**Waterloo Catholic  
District School Board**

***ADDENDUM # 001***

**St Anne Cambridge CES Renovation  
127 Elgin St N, Cambridge, ON N1R 0E1  
RFT No. 2026-11**

Thursday, 12 March 2026

**DRAWING NUMBER**  
E2 OF 5

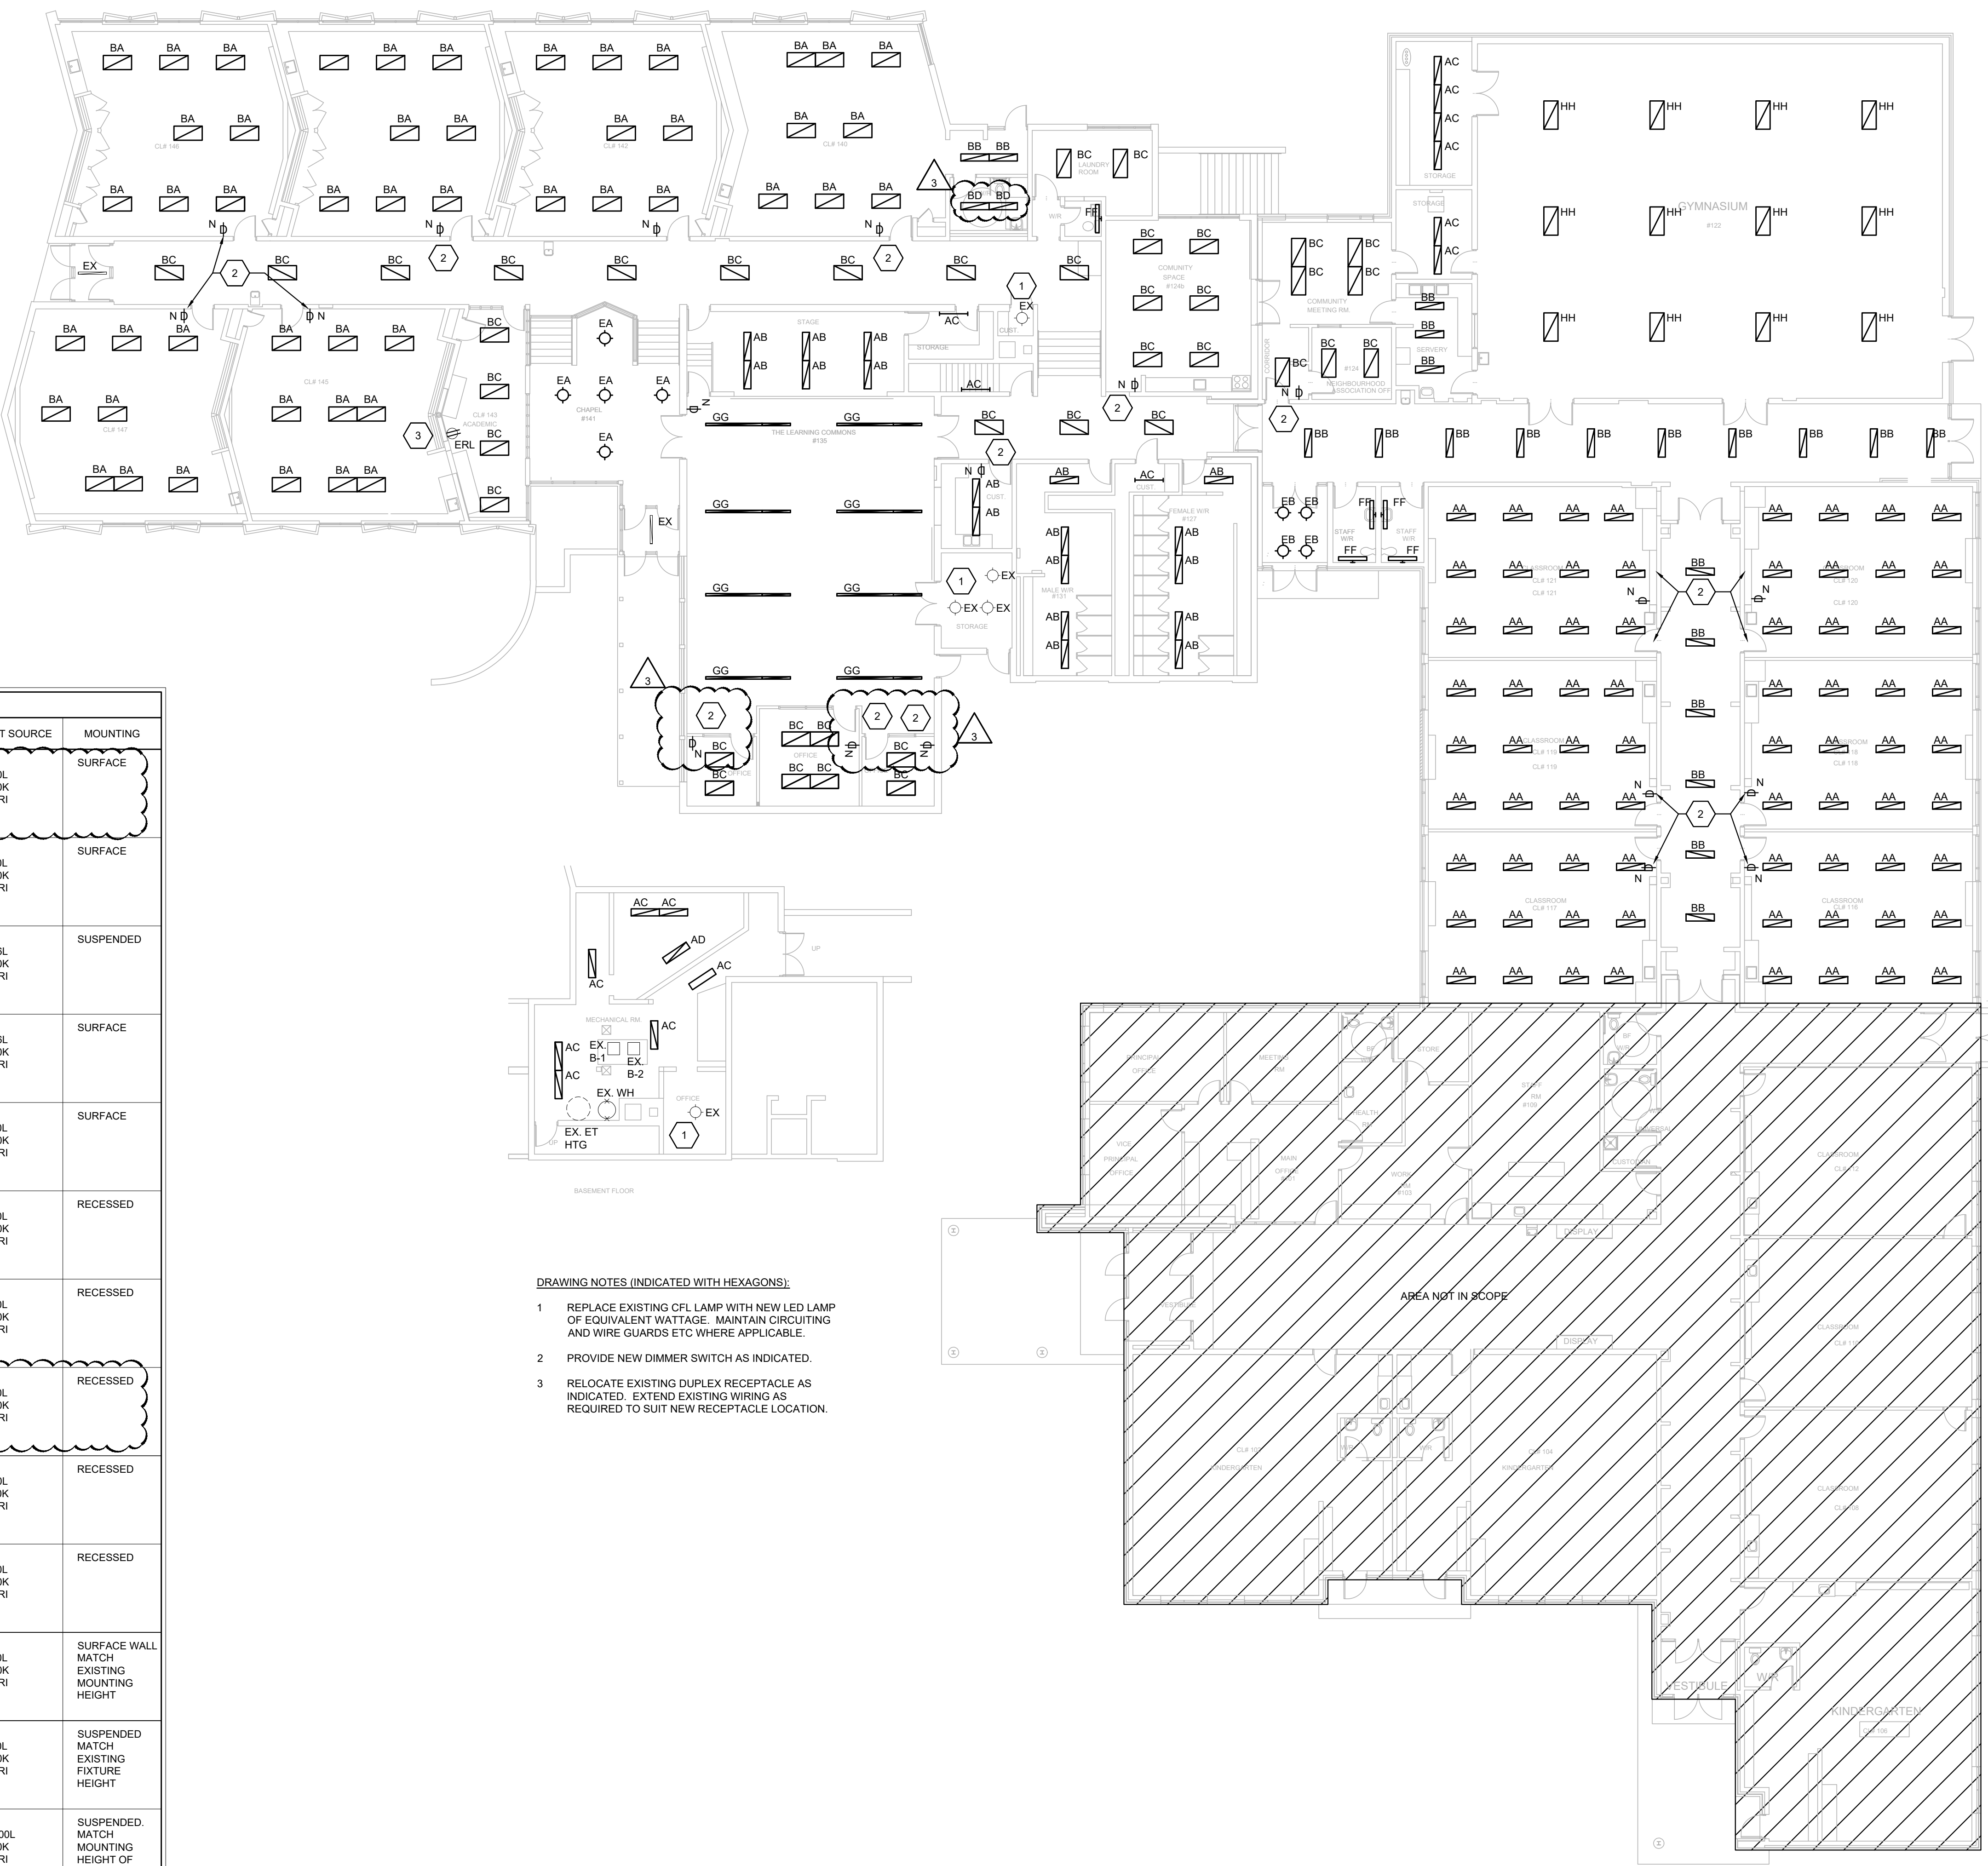
#### 2.1. Reissued Drawing E2:

- 2.1.1. Revise lighting fixture schedule, type AA, AB, BA, BC and BD.
- 2.1.2. Change fixture type in CL# 140 washroom.
- 2.1.3. Provide dimmer switches in Library Office.
- 2.1.4. Provide built in occupancy sensors in fixture type BC.

DRAWING NUMBER E5 OF 5

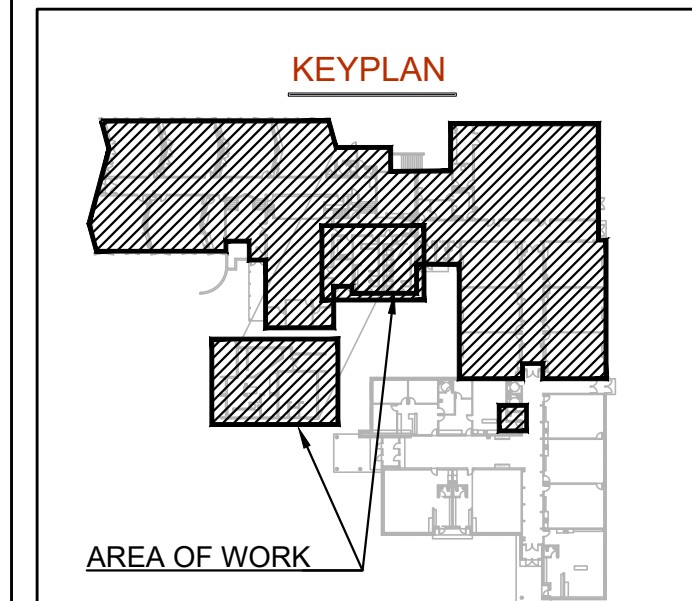
#### 2.2. Reissued Drawing E5:

- 2.2.1. Revise electrical specification as indicated on the drawings.
